Kimimage to City Centre Core Bus Corridor Scheme

NTA Observations on CPO Objections

March 2024

Figure 2-5-5: Extract from General Arrangement Map Sheet 7 at Pinch-Point

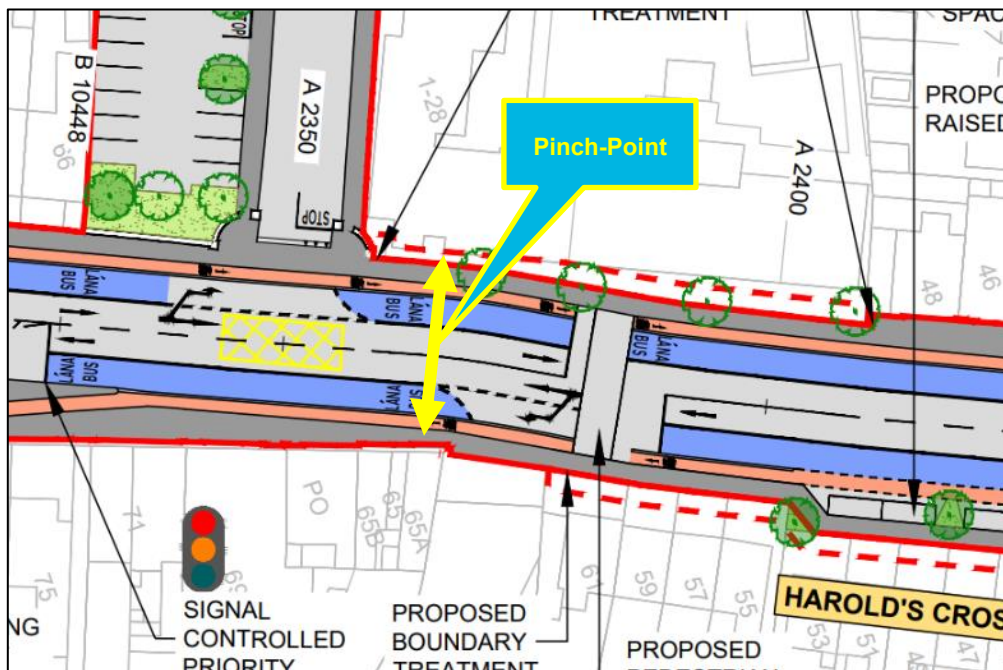
- a) Why widen only part of Harold's Cross Road and not the rest?

The existing road width between boundaries along Harold's Cross Road from Our Lady's Hospice at the southern end to Parnell Road at the northern end varies from a minimum of 17m at each end to a maximum of 22m in the central zone.

The standard cross-section for the core bus corridor with a 2m footpath, 2m cycle track, 3m bus lane and 3m traffic lane on each side requires a width of 20m. Road widening is therefore required where the existing width of Harold's Cross Road is less than 20m. However, at both ends of this section it is only feasible to widen the road to 19m because of the buildings at, or close to the road edge. This part of the Proposed Scheme therefore requires a relaxation of the width of the cycle tracks to 1.5m rather than 2m desirable. For consistency, the Proposed Scheme will provide 1.5m wide cycle tracks along the 400m length of Section 2 from Harold's Cross Park to the Grand Canal. This will require road widening over the 120m length from Our Lady's Hospice to Mount Drummond Avenue, and locally over a length of 25m at the corner with Parnell Road. The rest of this section of Harold's Cross Road is wide enough to fit the proposed road layout without widening into properties. The houses on the eastern side of the road have front gardens that can be encroached into for the necessary road widening, whereas on the western side of the road there is a row of shops with very small private landing areas in front, and north of Greenmount Avenue the frontage has a high boundary wall that separates the public road from very small gardens for the ground floor apartments in a duplex complex. It is more practicable to widen on the eastern side of Harold's Cross Road where the impacts for the properties will be considerably less than for the alternative of widening on the western side.

Figure 2-5-6: General Arrangements Drawing Sheet No.6 at Harold's Cross Park South

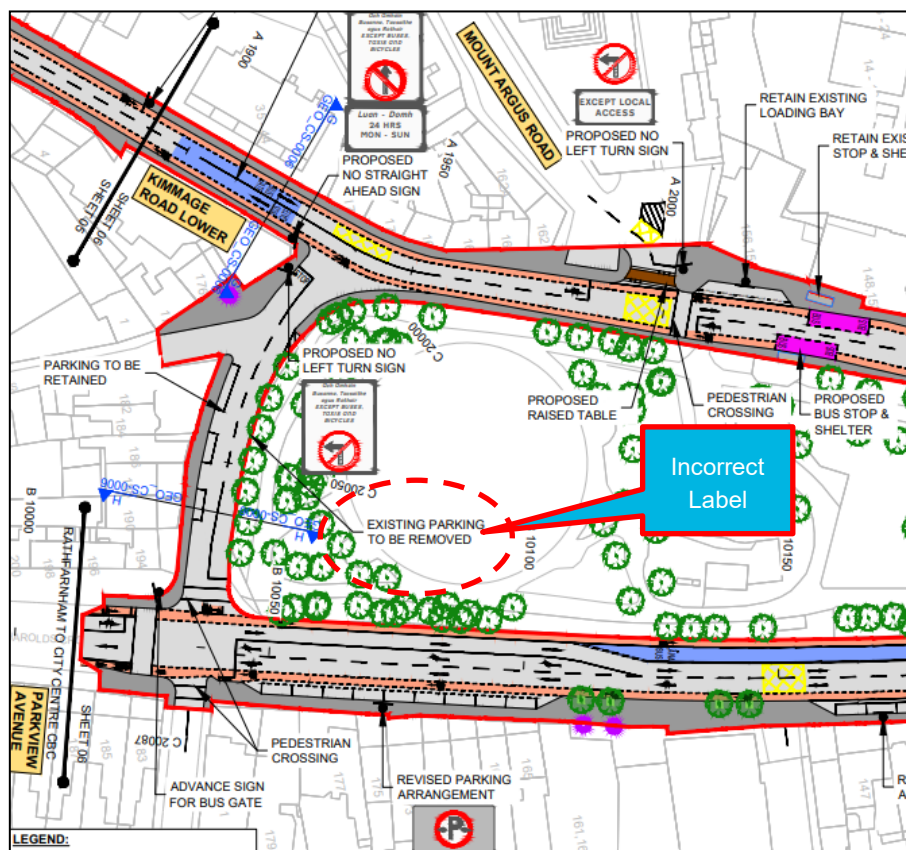
d) Road layout at Harold's Cross Park South.

This submission says that there is an incorrect label on General Arrangement Drawing Sheet No.6 which points to "Existing parking to be removed" on the northern side of the short link street at the southern end of Harold's Cross Park. That label should say "Existing footpath to be removed". This error is corrected in this response.

Figure 2-5-9: Proposed Scheme Drainage on Harold's Cross Road at Junction with Mount Drummond Avenue

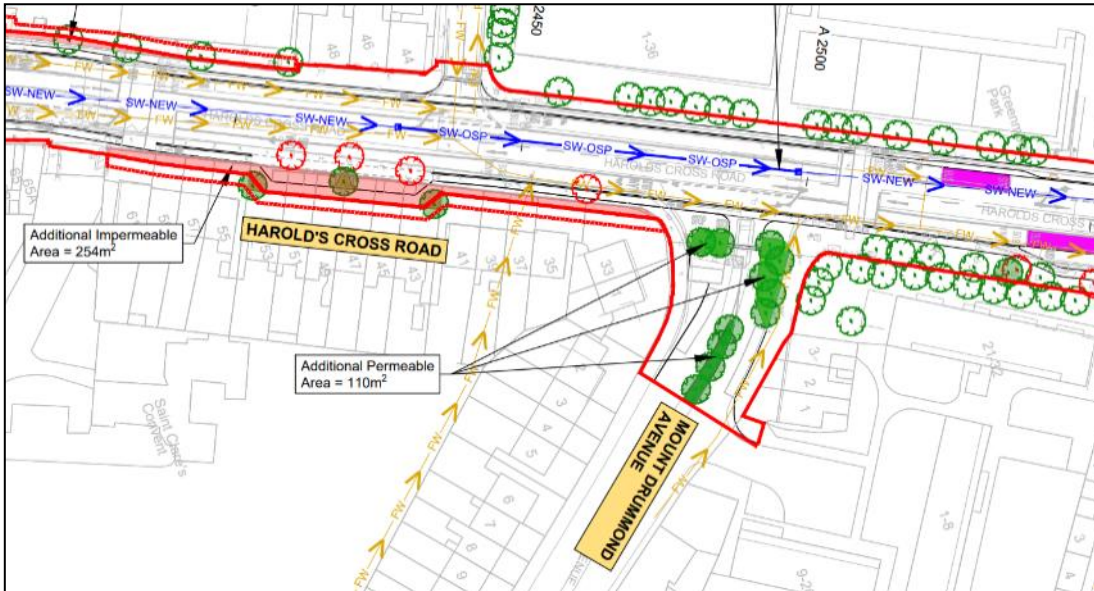
g) Drainage problems on Harold’s Cross Road / Mount Drummond.

In the Proposed Scheme at this junction the drainage issues described can be rectified. Harold’s Cross Road will be reconstructed as part of the proposed road widening, and this will include a new surface water drainage system as is shown in EIAR Volume 3 Figures, Part 11 Proposed Surface Water Drainage Works, Sheet 7, from which a snapshot is included in Figure 2-5-6.

Figure 2-9-5: Ownership of the Lands within Our Lady's Hospice

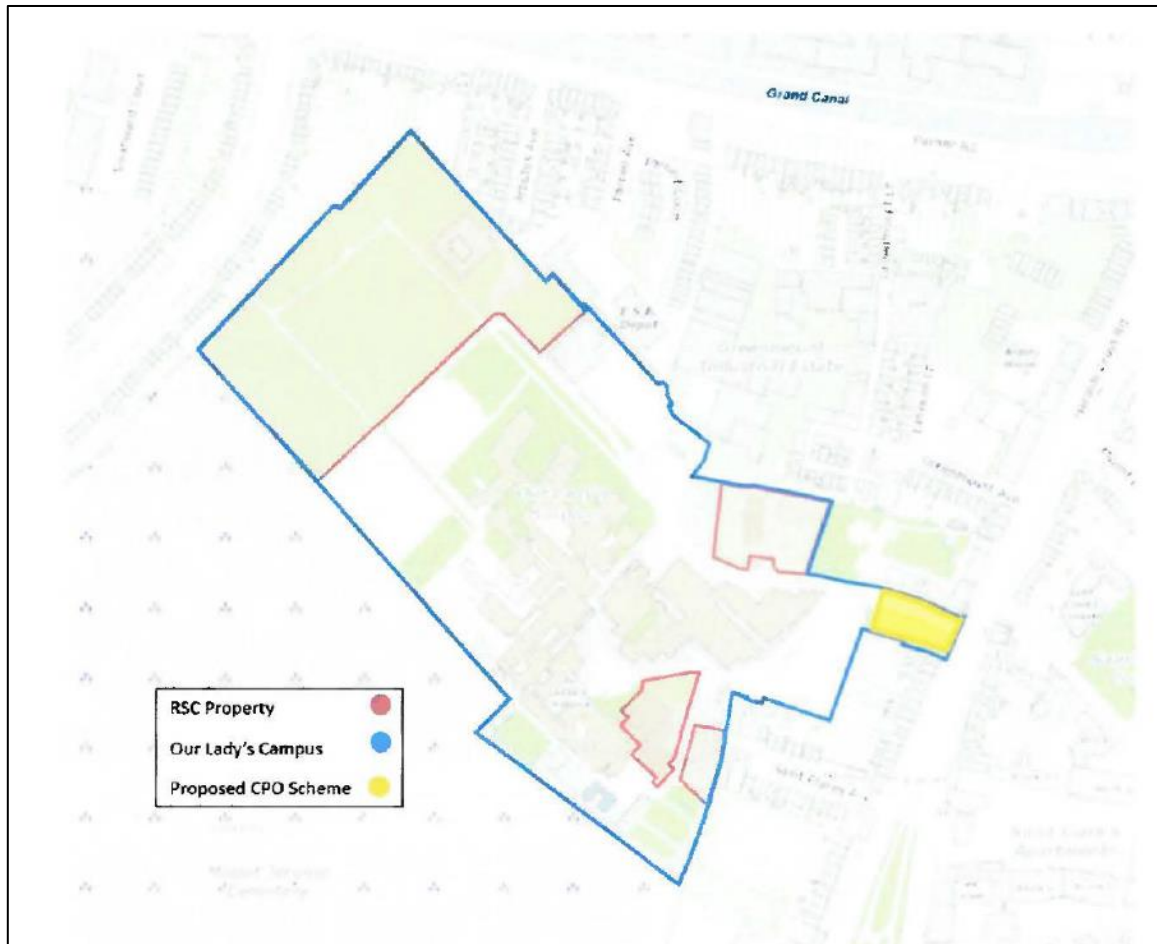
- b) Lands to the rear of the hospice are in separate ownership and not available as an alternative site for expansion.

In a separate Objection to the CPO by the Religious Sisters of Charity (CPO No.11) it is stated that the lands for the hospice were transferred from the religious order to Our Lady's Hospice Ltd. in 2002, while certain plots within the site and at the rear on the western side of the overall site were retained by the religious order. A map of the overall lands controlled by either the Hospice or the Religious Sisters of Charity is shown in Figure 2-9-5, which is extracted from CPO Objection No.11. It can be seen that there is a large area of undeveloped land at the rear of the site which is many times larger than the small Plot No.1019(2) in the CPO for the Proposed Scheme

Figure 2-9-6: Dublin City Council Parking Control Map

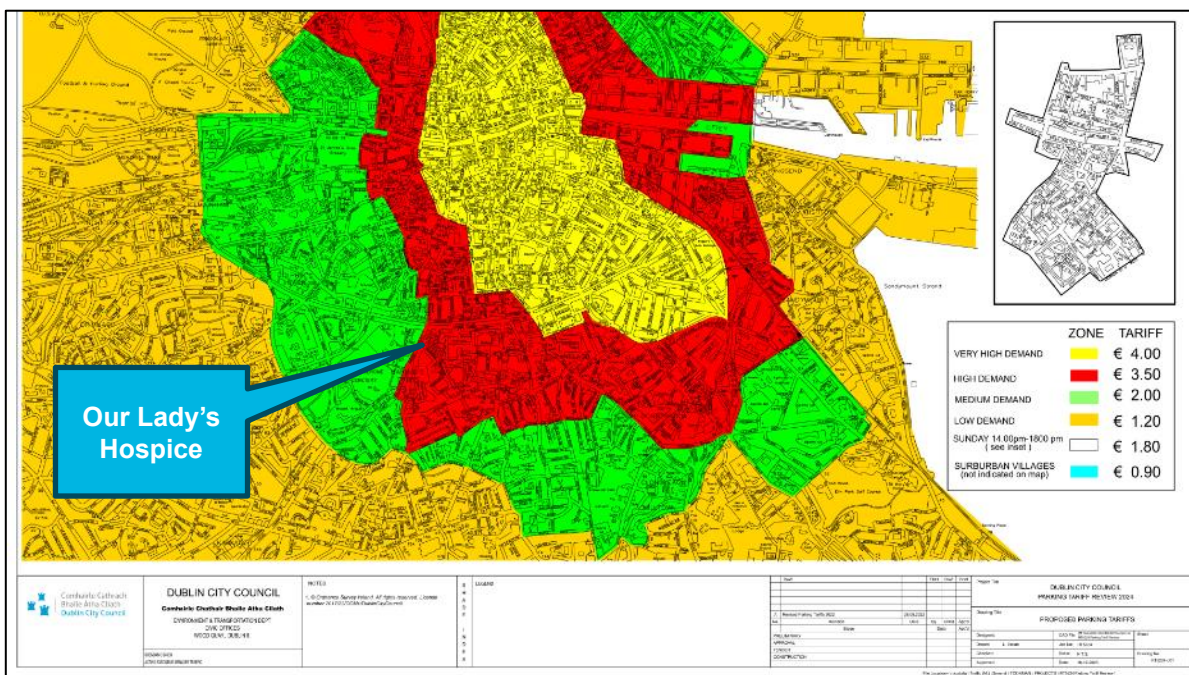
- c) Car park inconsistent with planning policies. Not suitable location for Park & Ride.

on the Dublin City Council Parking Control Map in Figure 2-9-6. The proposed car park could not be reasonably described as a Park and Ride facility

Figure 2-9-7: Construction Compound K2 at Our Lady’s Hospice

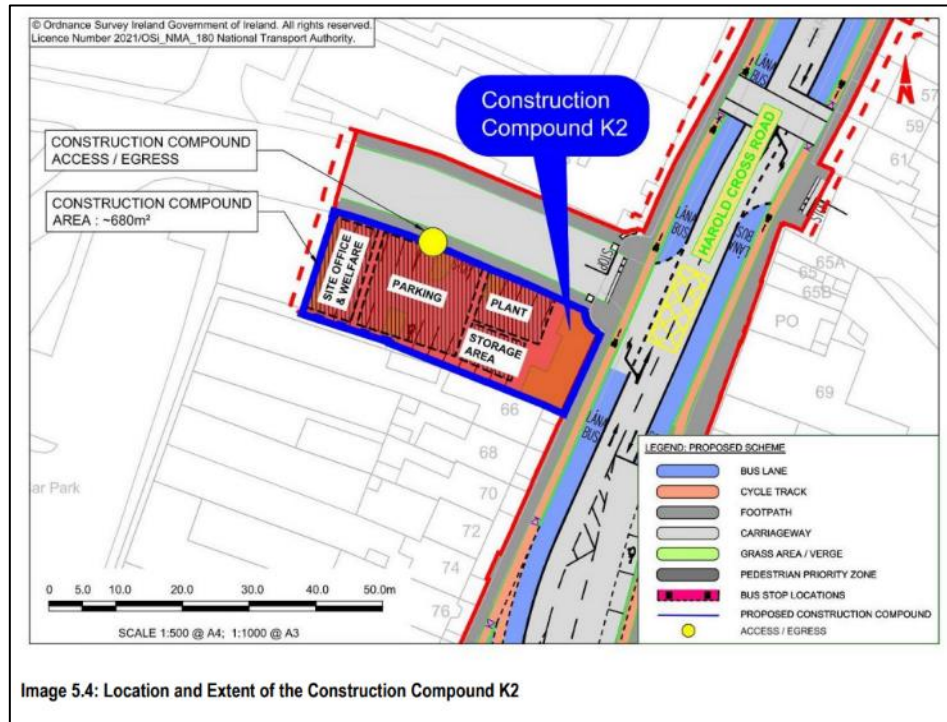
d) Access restriction beside construction compound / risk of traffic delays for access to hospice.
Inadequate assessment of impacts: noise and dust.

The proposed construction compound K2 will be located on the un-used grass lawn area along the southern side of the access road into the hospice as described in EIAR Volume 2, Chapter 5, Section 5.7. An indicative layout of the compound is shown in Image 5.4 in EIAR Chapter 5, and this is reproduced in Figure 2-9-7 below. The compound will not impede access to the hospice which will continue along the existing access road beside the proposed compound.

Figure 2-14-6: Proposed Landscaping at St. Patrick’s Court

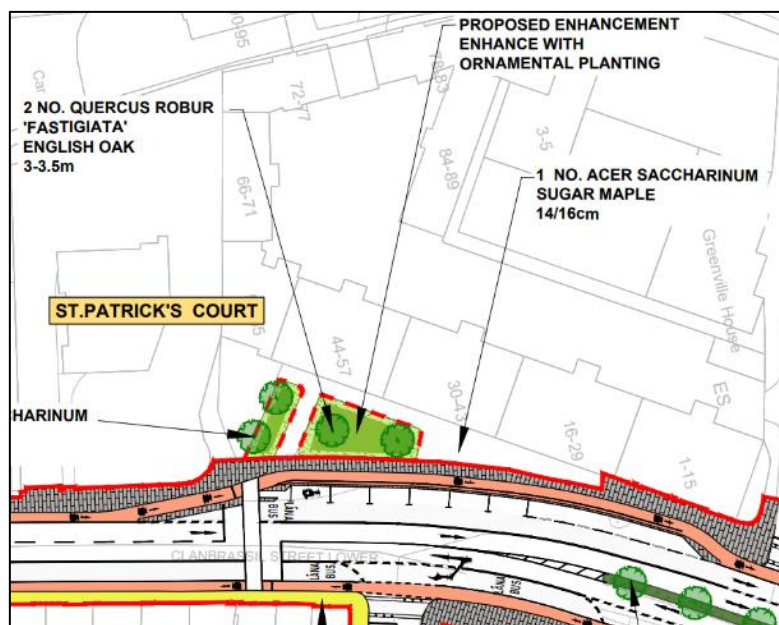
f) Loss of green space.

The loss of these small green spaces will be only temporary, and they will be reinstated with enhanced planting as shown in the landscaping drawings (EIAR Volume 3 Figures, Part 5, Sheet 8) to improve the amenity for long-term benefit to the local community and businesses.
